VILLAGE OF CALEDONIA UTILITY DISTRICT MEETING AGENDA

Wednesday, July 5, 2023 – 6:00 p.m.

RE: Engineering Improvement Plan Approval – Prairie Pathways Phase V

The Caledonia Engineering Department has performed a review of Engineering Improvement Plans dated 5-19-2023 for the Prairie Pathways Subdivision:

SHEET
3
 OF
20

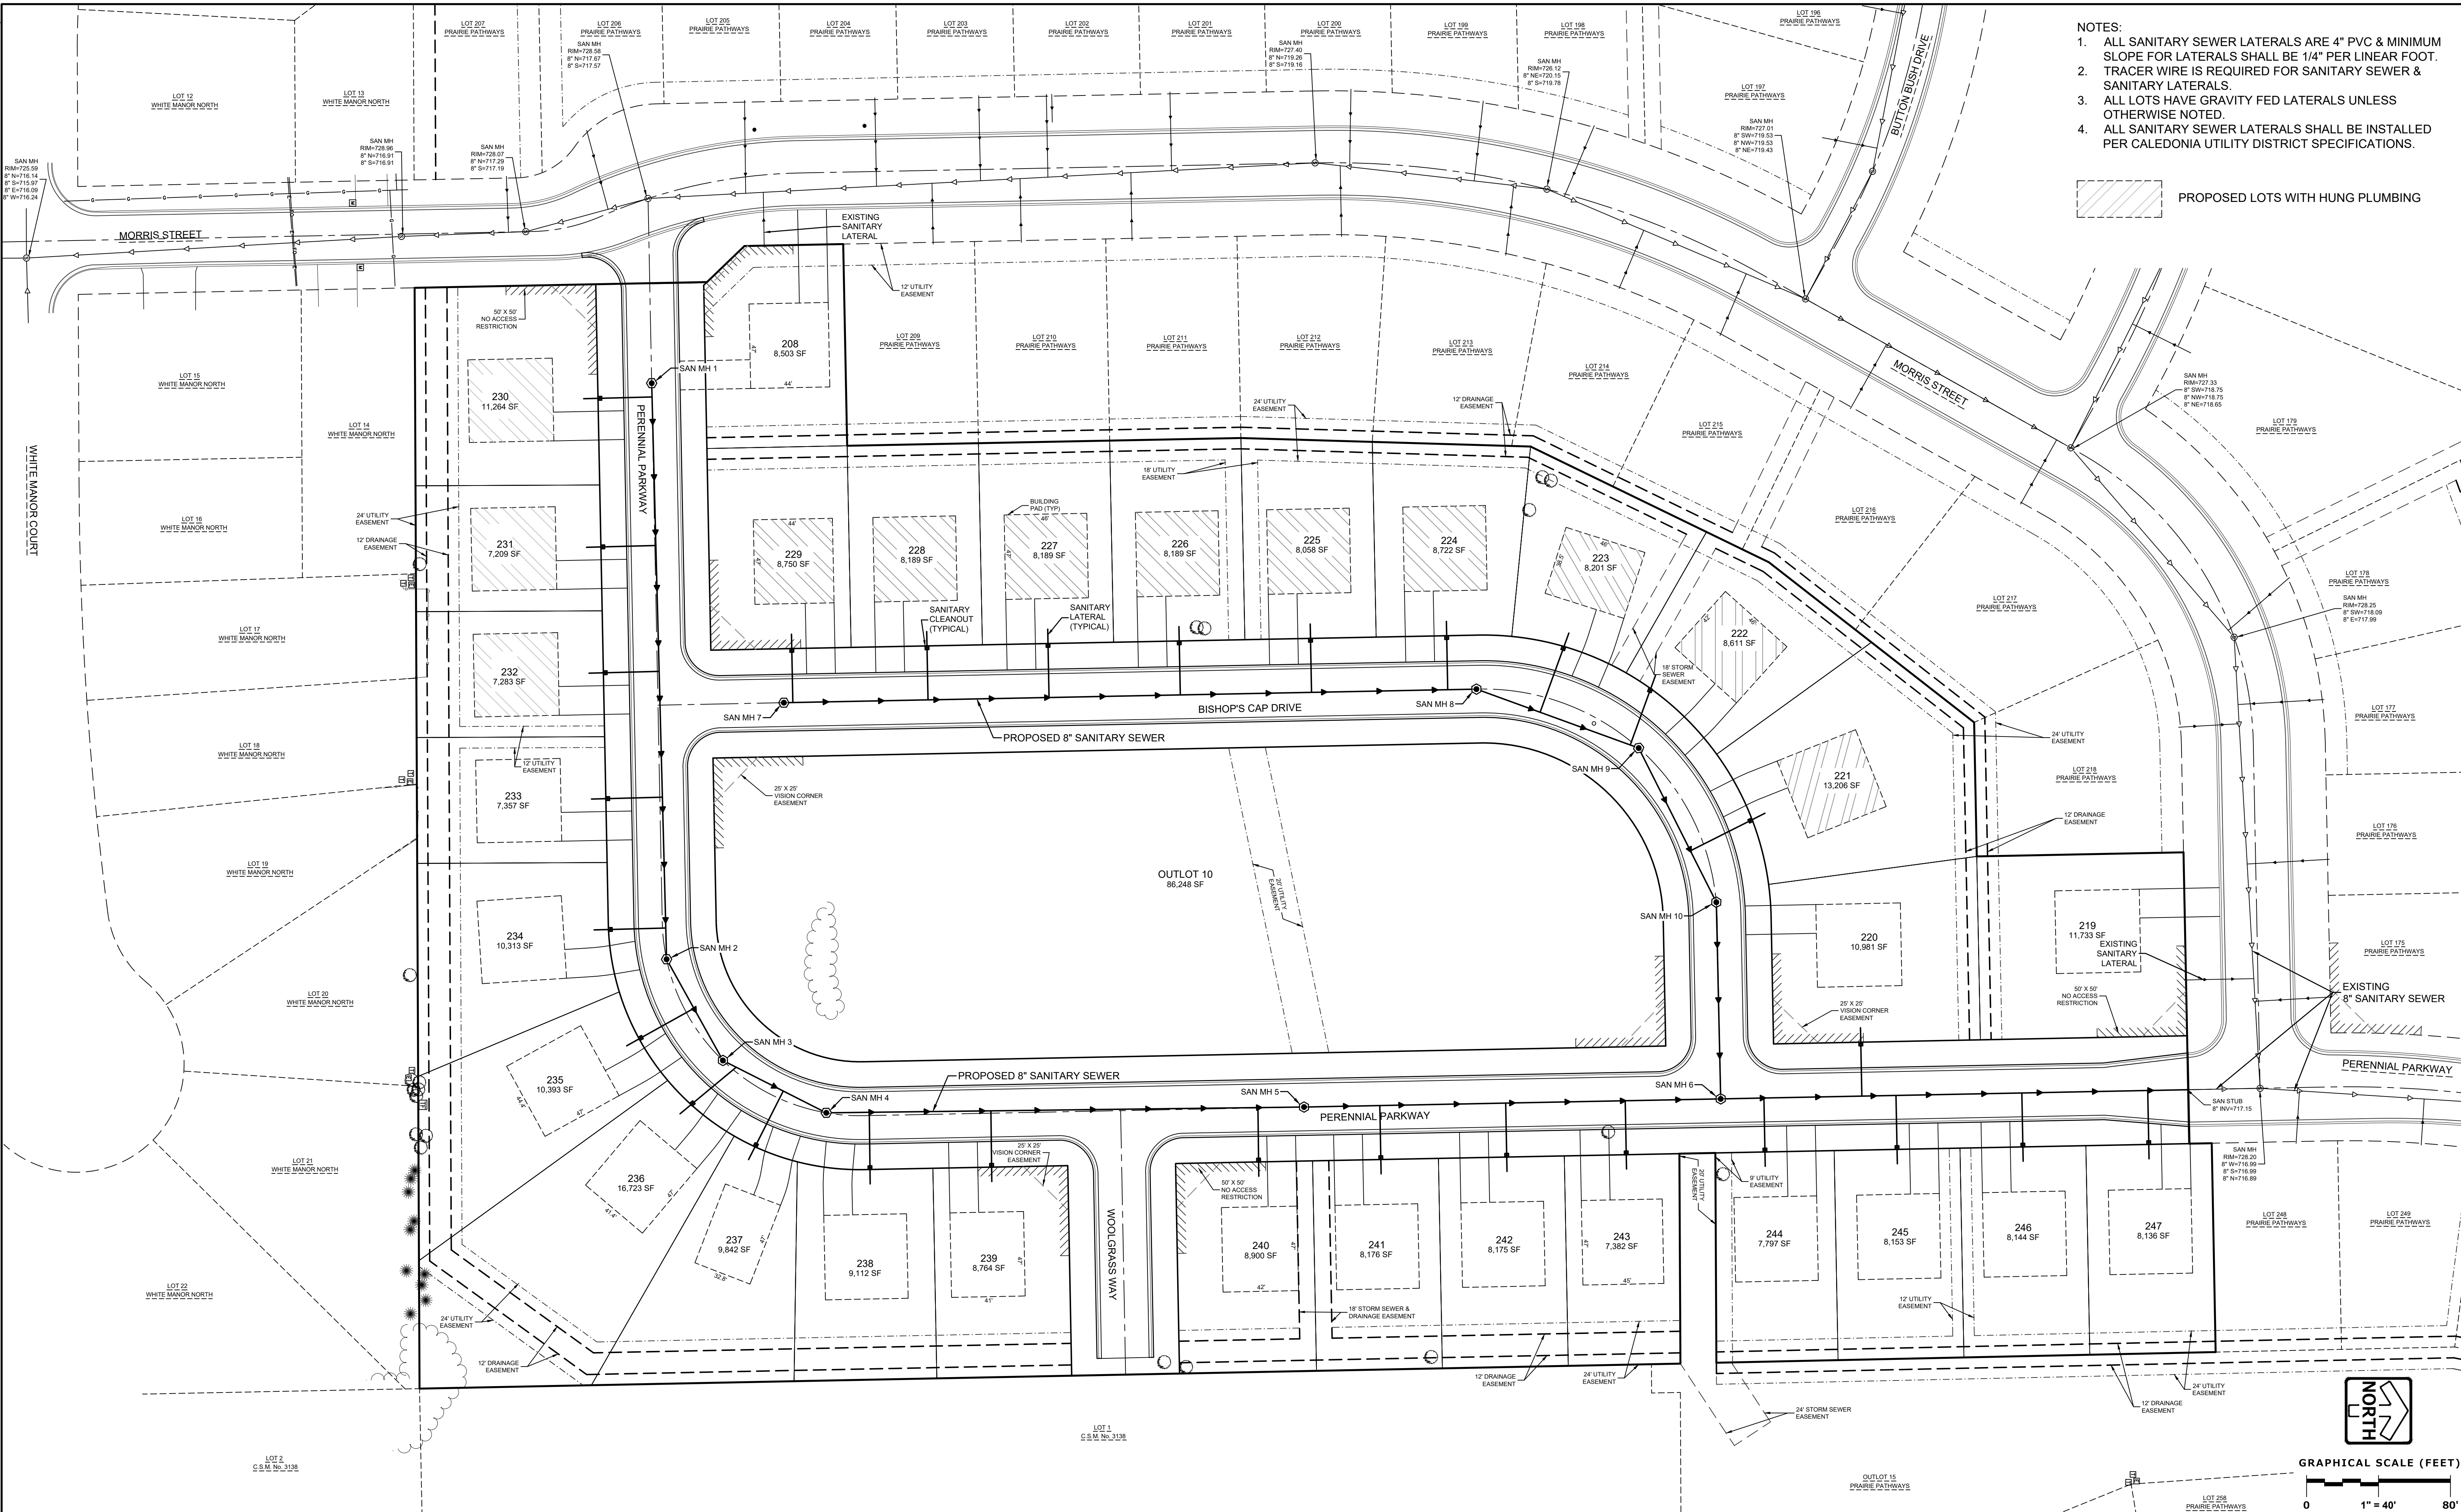
Sheet 3

- Please show the approved and proposed master grading plan elevations for the rear yard of 219-229. While it is understood what the as-built elevations are, the intention is still to meet the approved master plan grades. You may include the current elevations as "E ###.##" for existing and P"XXX.XX" for the proposed (or some format of similar design).
- Lot 218/219 has significant difference from Phase III plan to current proposal at shared lot line (Prop 730.60 – Actual 730.12) FYG should be 0.7' min. from the proposed master grading plan side yard swale. The FYG for Lot 218 is 731.30.
- Storm Sewer behind Lot 227/228 still incorrect. Please extend the sump collection system to the center of lot 228 and provide perpendicular connections to the newly extended system.

- All sump collection cleanouts should be located at the edge of the easement line (whole plan).

- Shift sump collection line for Lot 233 to rear of new inlet to eliminate long crossing.
- Note: Extra courses in foundations may be required on project due to greater than 4' of fill required to reach FF. Please notify builder/developer or provide a note on plans.
- Show Lot 219/220 option for driveway on side street as was done for the lot on Morris. 219 may be too steep but 220 can have the option shown with possible slope. We liked how this was done.
- Provide Street Lighting locations

SHEET
7
OF
20

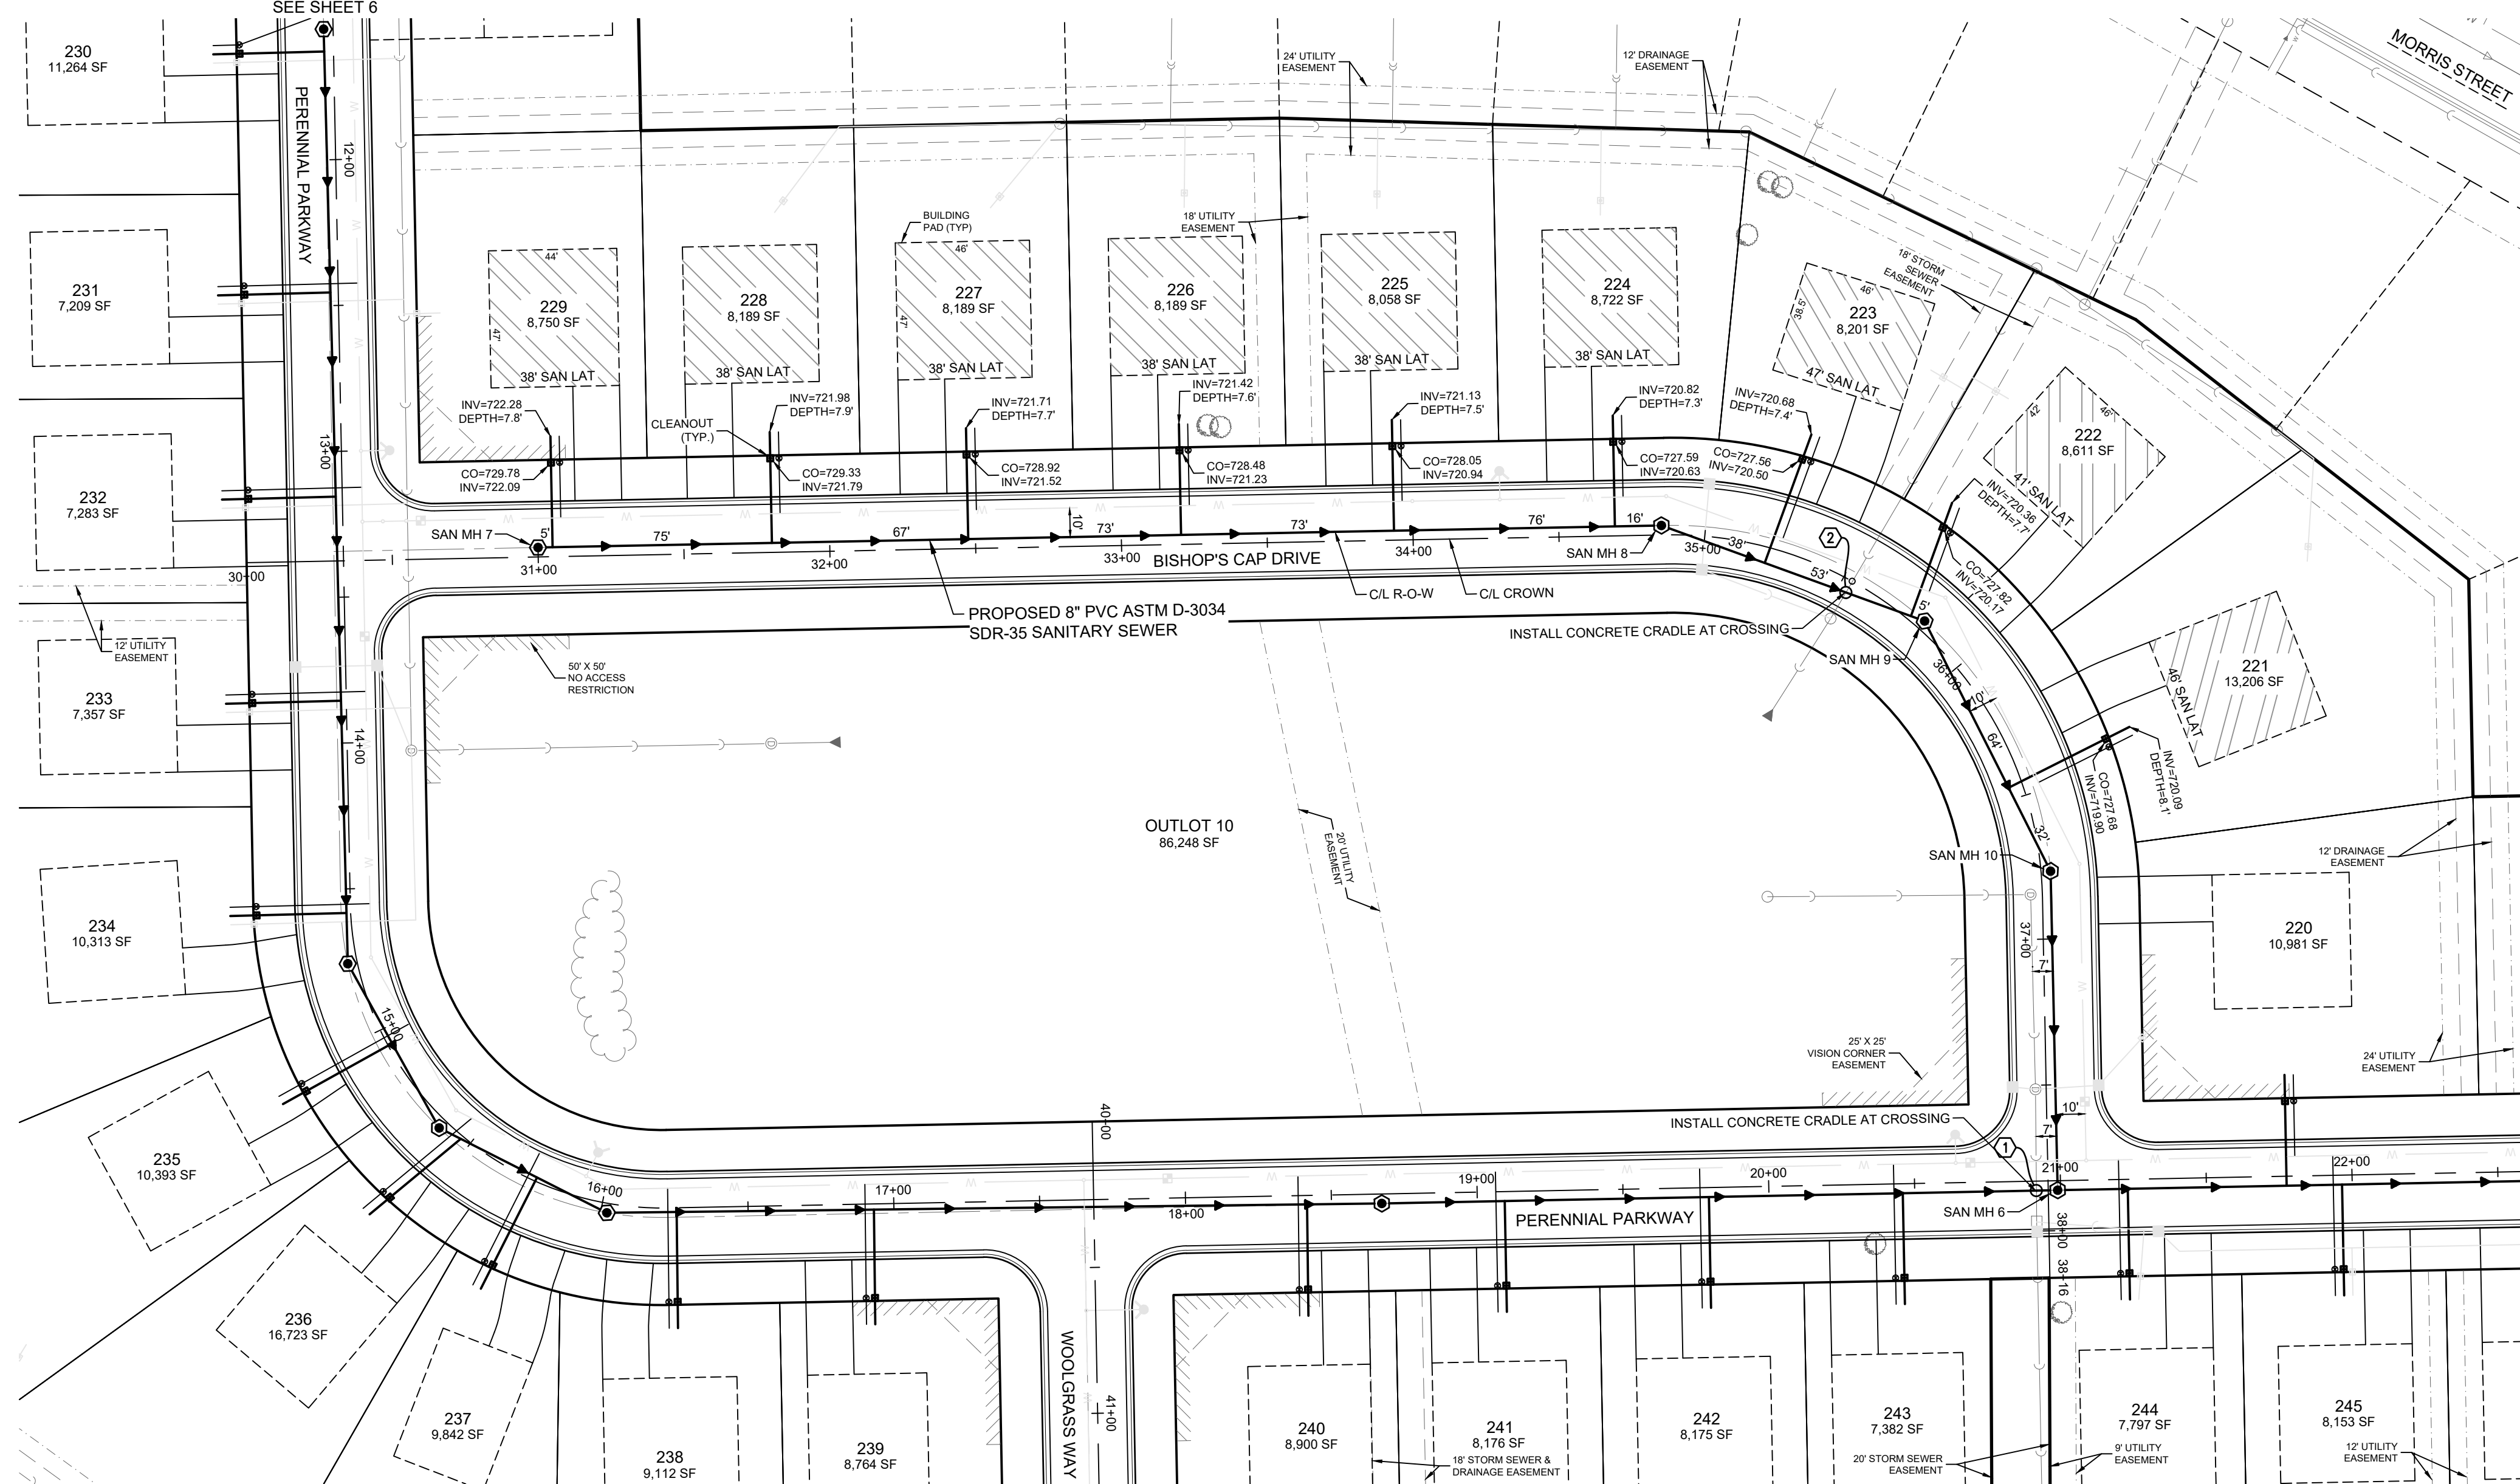
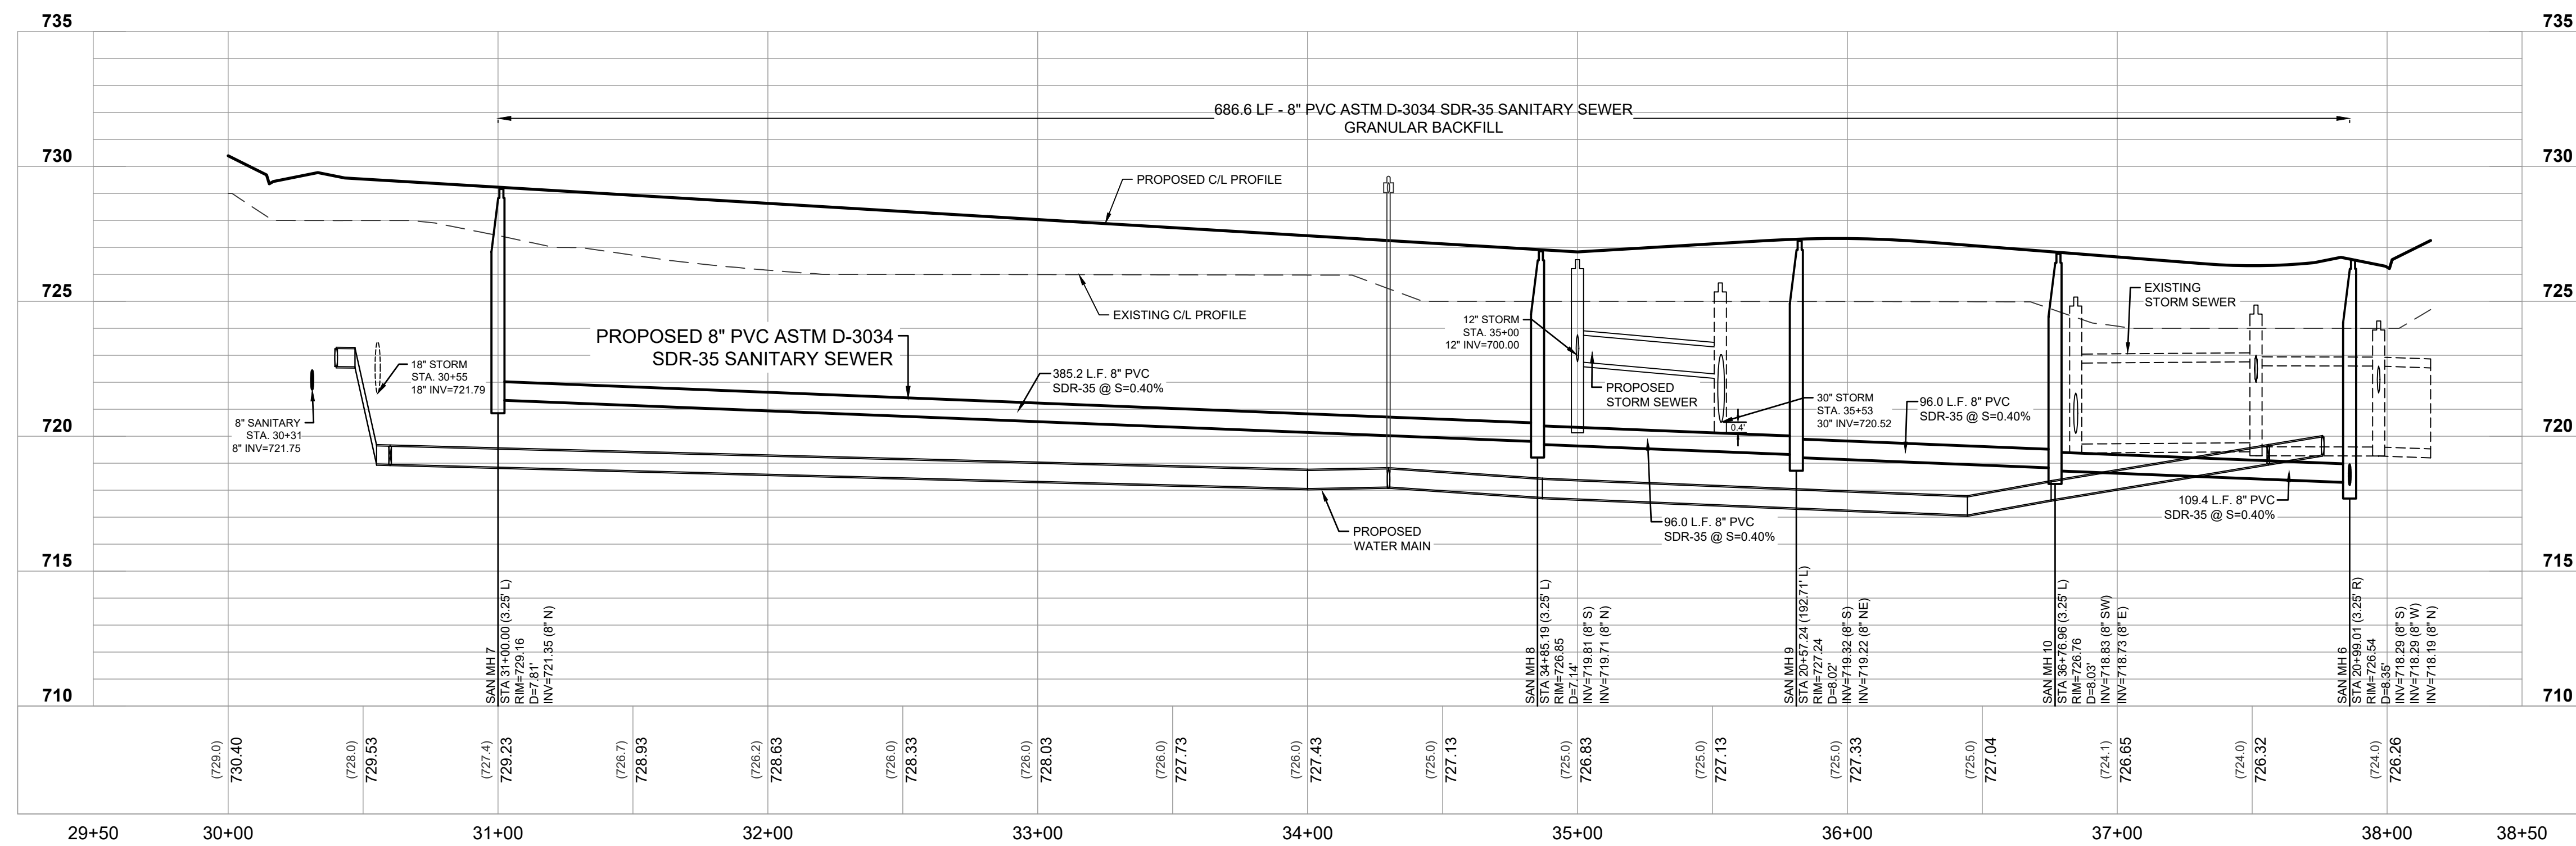
Sheet 7 / Storm Sewer Crossing Conflict

- Sanitary / Storm crossing conflict is an issue.
 - Clarify bottom of storm pipe elevation because the invert is 719.60 at the downstream manhole; so the bottom of a 36" pipe would be much lower due to thickness.
 - Double check elevation of top of pipe for sanitary. We are getting closer to 719.12 for top of pipe.
 - Revisit storm sewer modeling required for this system. The existing 36" was installed when there wasn't a pond in the current outlot. There is only an 18" outlet structure and the 36" mainline may no longer be required. Consider relaying the 36" segment of pipe to a smaller size from the manhole that requires deck modification back up to 18". Would possibly resolve clearance issues.
